Preliminary Change Request for the SNS 1.3 GeV-Compatible Ring

BNL/SNS TECHNICAL NOTE

NO. 076

May 4, 2000

Figure 5: Layout of the proposed 1.3 GeV-compatible lattice for the Spallation Neutron Source ring.

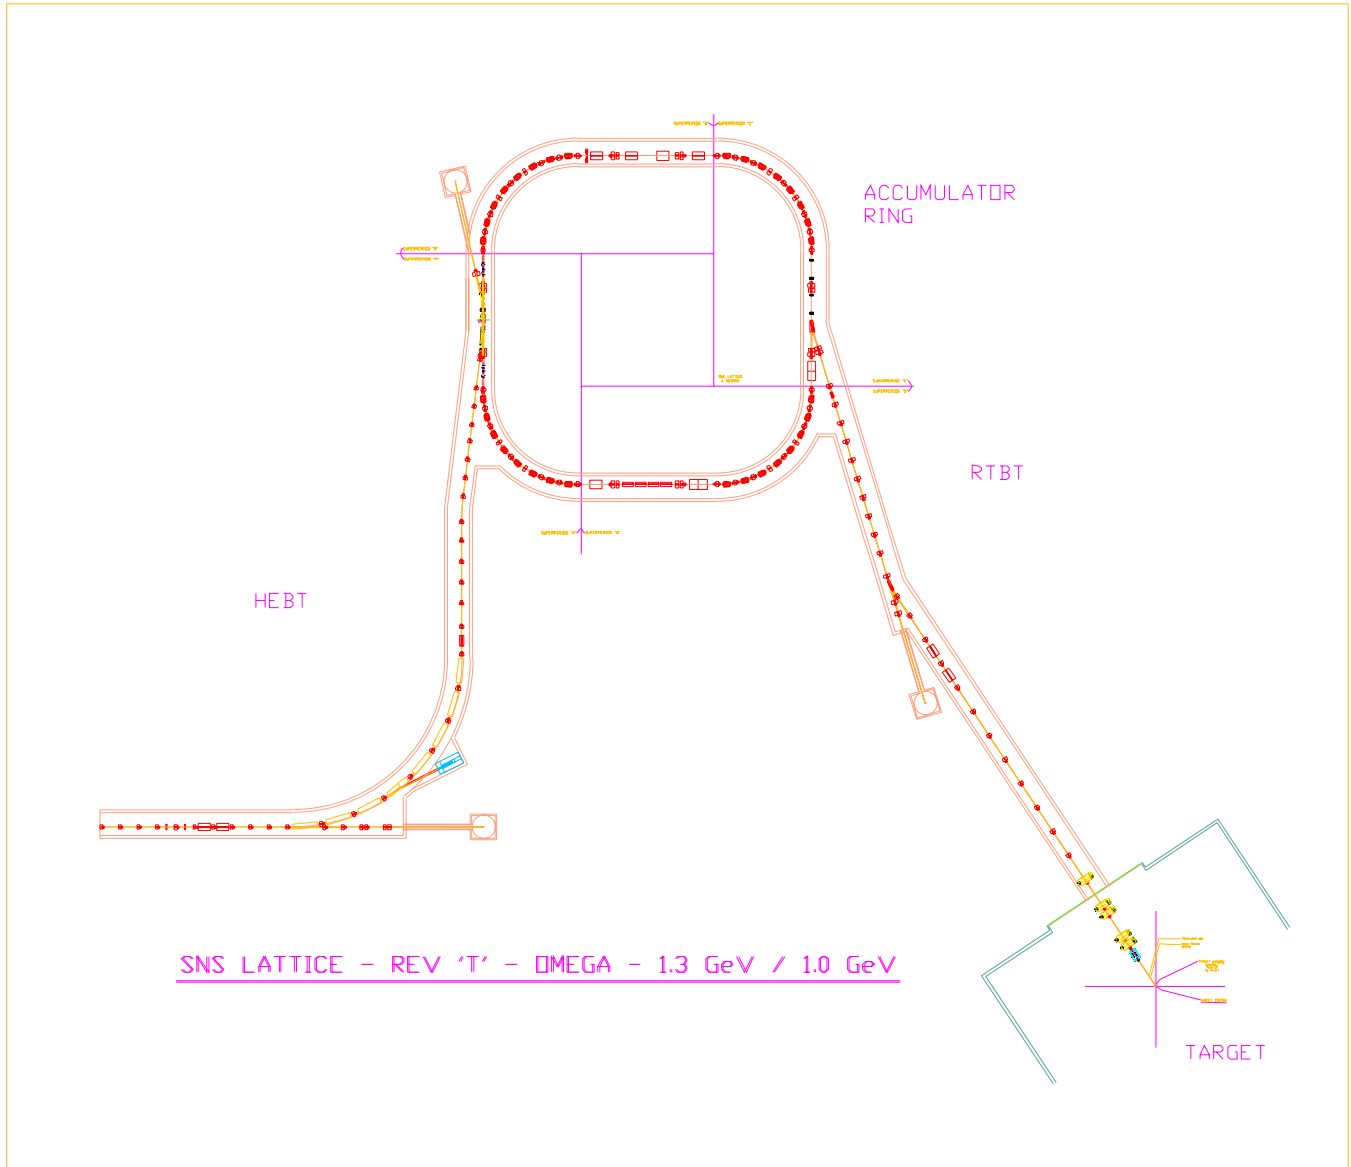
The proposed layout is again in omega configuration, as shown in Figure 5. The bending radius of the 90° achromat bend of the HEBT is increased due to the reduced dipole field. The HEBT length becomes 162 meters, 25 meters longer than the original. The length of the RTBT is assumed unchanged at 150 meters.

The ring lattice is four-fold symmetric with each super-period containing one FODO arc section and one doublet straight section. The arc section consists of four 8-meter long FODO cells, each with a horizontal betatron phase advance of 90 degrees. The dispersion-free straight section consists of one 12.5-meter and two 6.85-meter uninterrupted drift spaces. The increase in ring straight length results in an increase in ring circumference from 220.88 to 248.0 meters.

Figure 6: Schematic layout of the proposed 1.3 GeV-compatible SNS ring.

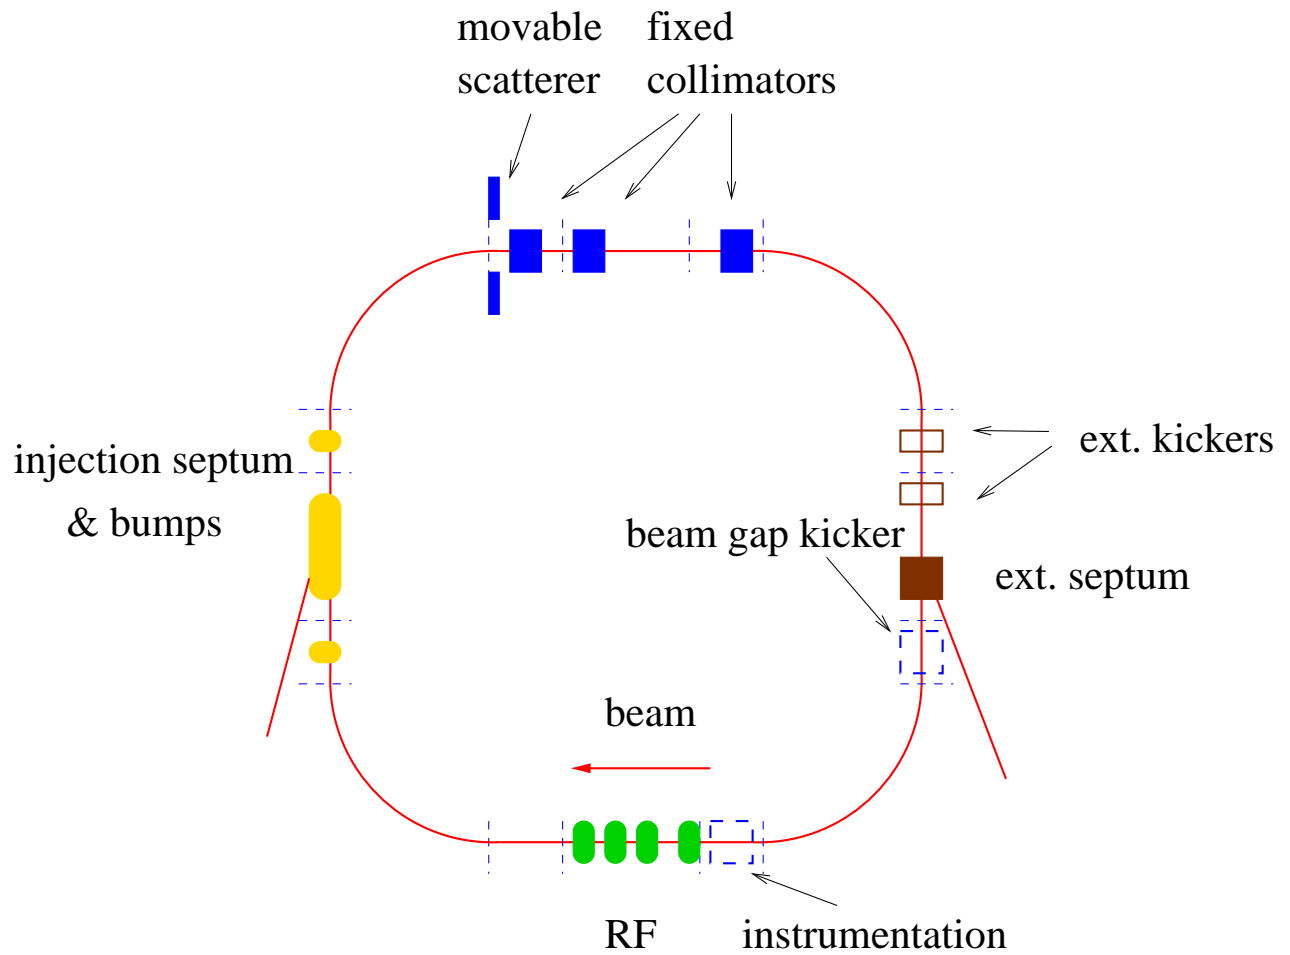
Figure 6 shows the schematic layout of the ring. The four straight sections are mainly designed for beam injection, beam collimation, extraction, and RF systems. All four RF cavities (three $h = 1$, one $h = 2$) are located in the same drift space. Figure 7 shows the layout of the lattice magnets (dipole, quadrupole, sextupole, and correctors) in one of the four lattice super-periods. Dipole correctors in both the arc and straight sections are used for misalignment closed orbit correction. The sextupoles in the arc sections are used for chromaticity adjustment, off-momentum optics matching, and momentum aperture improvement. The multi-layer correctors in the straight sections are used for resonance corrections.

Each of the 4 lattice period contains a straight section that has one 12.50 m and two 6.85 m drift spaces. The total straight section length is about 104.8 meters. For each drift space, the “overhead” taken by correctors, BPMs, vacuum pumps, bellows, flanges, etc. is about 1.6 meters. The total usable length is about 85 meters. Each period has 5.2 m – 11 m – 5.2 m structure. The total unclaimed drift space is adequate for an upgrade to a 1.3 GeV machine.

Figure 16: Extraction layout and closed orbit of the 1.3 GeV-compatible ring. The two kickers marked with blue color are reserved for 1.3 GeV operation.

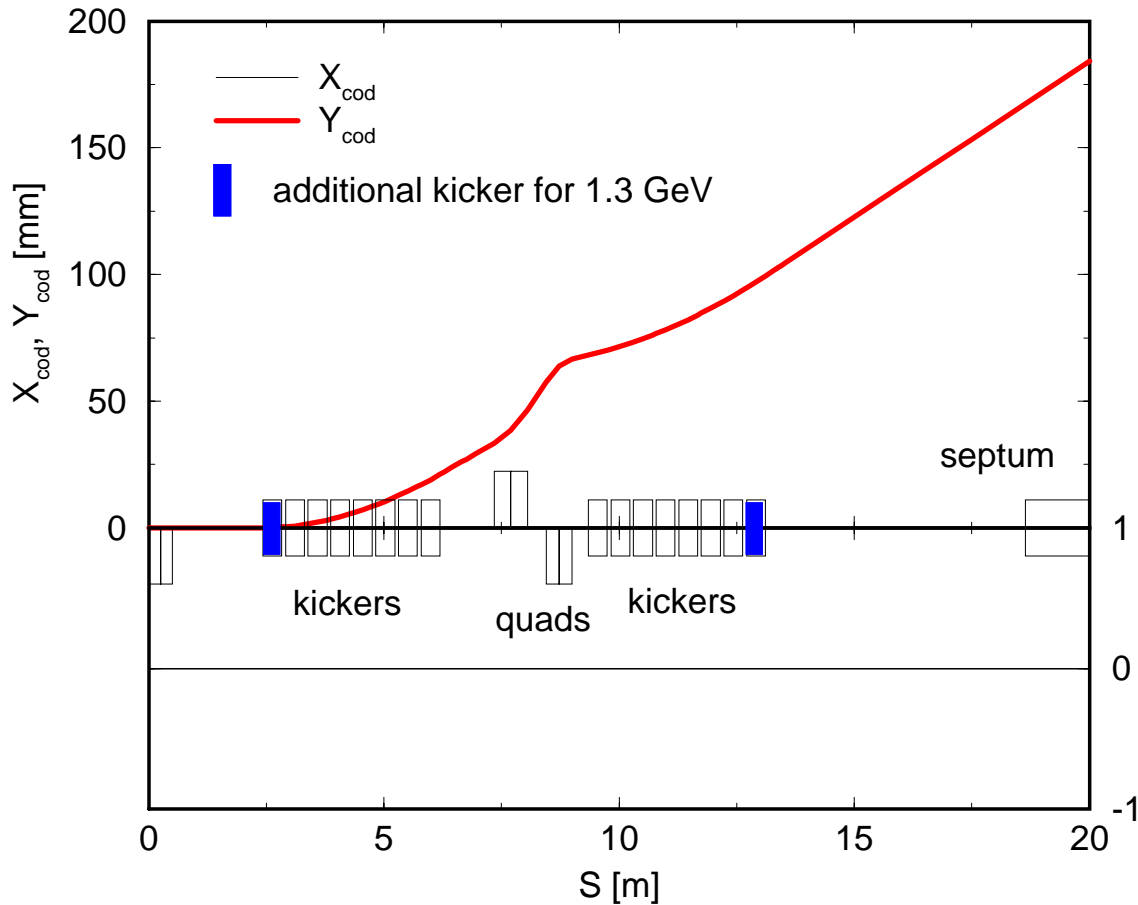
Space is reserved for the addition of two extra kickers for 1.3 GeV operation without changing the location of the existing 14 kickers.

The number and strength of extraction kicker modules remains the same, but the dimension is increased. The length of extraction Lambertson septum is increased from 2.1 to 2.4 m. Space is reserved for addition of two kicker modules for 1.3 GeV operation.

Figure 17: Horizontal schematic layout of the beam injection region of the proposed ring operating at 1.3 GeV.

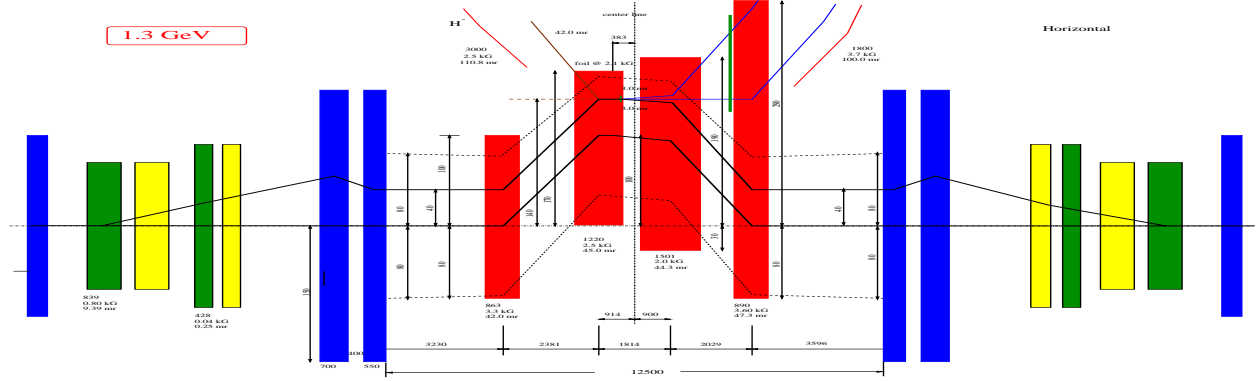
Comparing with 1 GeV operation, for 1.3 GeV operation two injection dipoles need to be

replaced by approximately 40% longer units operating at reduced (20%) fields, as shown in Figure 17. The location of the foil mechanism is also changed. Major parameters for the injection magnets are listed in Table 22. The 2.5 kG field of the magnets INJSEPTM1 and
